STATE OF CALIFORNIA
STATE AND CONSUMER SERVICES AGENCY
CALIFORNIA BUILDING STANDARDS COMMISSION
2525 NATOMAS PARK DR., SUITE 130
SACRAMENTO, CA 95833
(916) 263-0916 Phone
(916) 263-0959 Fax
Email: cbsc@dgs.ca.gov

PARTICIPATION COMMENTS FOR THE NOTICE DATED OCTOBER 26, 2012
Written comments are to be sent to the above address.

The Agency proposed modifications As Submitted on Section No. _11B-406

Figure 406.4
Landings at the Top of Curb Ramps

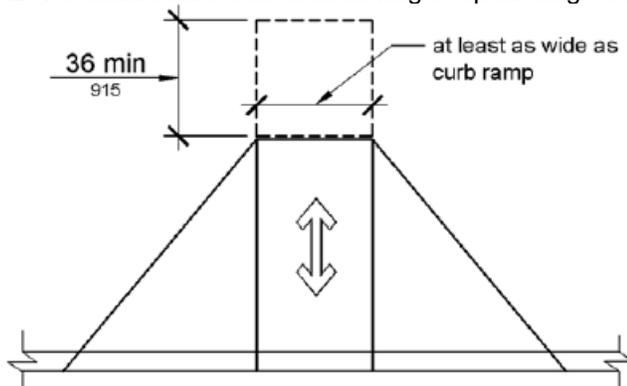
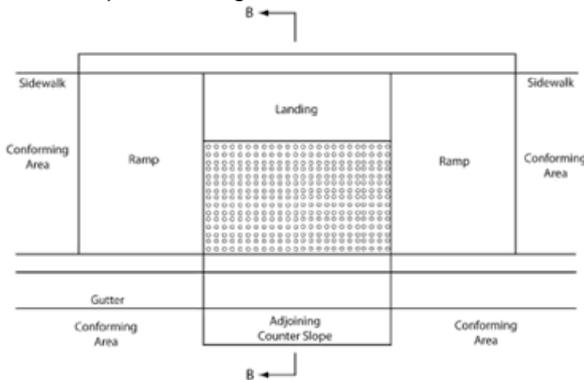
Top Landing for Parallel Curb Ramps This is problematic for parallel ramps, as stated. Topography (sidewalk slope) and conflicting adjacent infrastructure are often problematic, especially in a City like San Francisco. It would be prudent to have language with the standards to allow agencies to build the best case ramp in a difficult situations. One can't always comply in a difficult space and the agency should be given an exception for these occasion if the situation is documented in the project file with photos and measurements. Cities have 1,000s of ramps and potentially needing 100s of easements or relocating countless driveways is not a good use of limited resources, staff time and \$\$\$. Suggestion: provide waiver if natural topography will not allow improvement with reasonable effort.

By melding the 2010 ADA Standards with language from the draft PROWAG, a mandated top landing for the parallel curb ramp is now created. No landing requirement is stated in the 2010 ADA Standards for a parallel curb ramp (Case C curb ramp in Standard Plan A88A) because a parallel curb ramp is not mentioned or shown in the illustrations. A perpendicular curb ramp (Case A curb ramp in Standard Plan A88A) is the type shown in the 2010 ADA Standards illustration as having a top landing. See Figure 406.4 below.

The complication is created is when the highway is on a grade and the sidewalk follows the same grade. We are currently able to provide a curb ramp that will go from the sidewalk grade to a 1:12 (8.3%) grade for a parallel curb ramp. But, this revision will make us provide a 4 level landing first and then ramp down at 1:12. This is also a problem at corners with driveways near the corner. We will now need extra length to provide a level landing of 4 ft on each side. With a double parallel curb ramp (doubles are an advisory standard in Index 105.5 of the [HDM](#)) this becomes very lengthy and we will have to pursue R/W (easements, fee,..) or have to relocate the private driveway and probably compensate the owner.
